# Access Compliance Report

### (Curb Ramps)

Intersection ID: 44404	Main Street: FLOUFISHER_CT	Cross Street: BOBHOUSE_DR	Location:	SW
ADA ID: 9A1B3367D1A2	Ramp Type: PerpDiag	Initial Pass/Fail: Fail	Overall Compliance: No	Severity Score: 30
Codes/Mitigation Info/Possible Solution		Field Measurements/Component Compliance

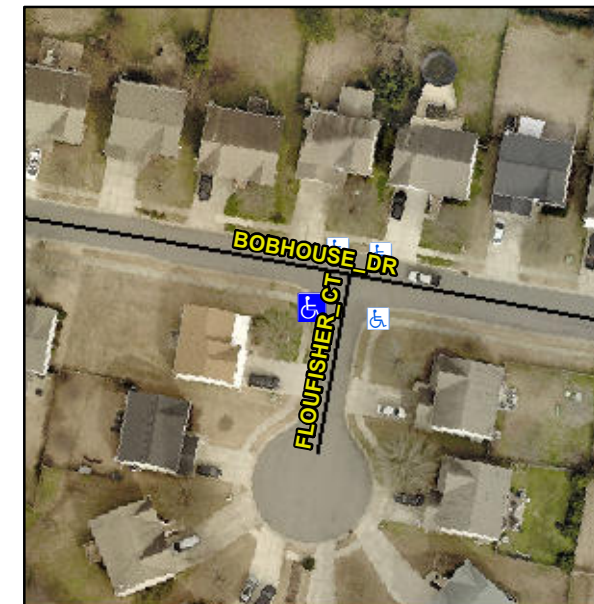
**Not Found, R304.5.1, R304.5.3**

Compliance	Description	Data	Compliance	Description	Data
N/A	Ramp Length (in)	48.0	Yes	Ramp Slope (%)	6.6
No	Ramp Width (in)	34.0	No	Ramp XSlope (%)	5.5
N/A	Flare Type LT	N/A	N/A	Flare Type RT	N/A
N/A	Flare Slope LT (%)	N/A	N/A	Flare Slope RT (%)	N/A
N/A	Flare Traversable LT?	N/A	N/A	Flare Traversable RT?	N/A
N/A	Landing Length (in)	N/A	N/A	DWS Provided?	N/A
N/A	Landing Width (in)	N/A	N/A	DWS Contrast?	N/A
N/A	Landing Slope (%)	N/A	N/A	DWS Length (in)	N/A
N/A	Landing X Slope (%)	N/A	N/A	DWS Full Width?	N/A
N/A	Landing Curb? (Y/N)	N/A	N/A	DWS Offset (in)	N/A
N/A	Shared Landing?	N/A			
N/A	Gutter Ponding?	N/A	N/A	Gutter Slope (%)	N/A
N/A	Gutter Lip Ht (in)	N/A	N/A	Gutter X Slope (%)	N/A
N/A	Painted X Walk1?	No	N/A	Painted X Walk2?	No
	X Walk 1 Direction	To NE		X Walk 2 Direction	To NW
N/A	X Walk 1 Width (in)	N/A	N/A	X Walk 2 Width (in)	N/A
	X Walk 1 Slope (%)	0.5		X Walk 2 Slope (%)	0.6
	X Walk 1 X Slope (%)	2.8		X Walk 2 X Slope (%)	1.9

**Remove & Replace Curb Ramp With Two New Directional Ramps or Equivalent.**
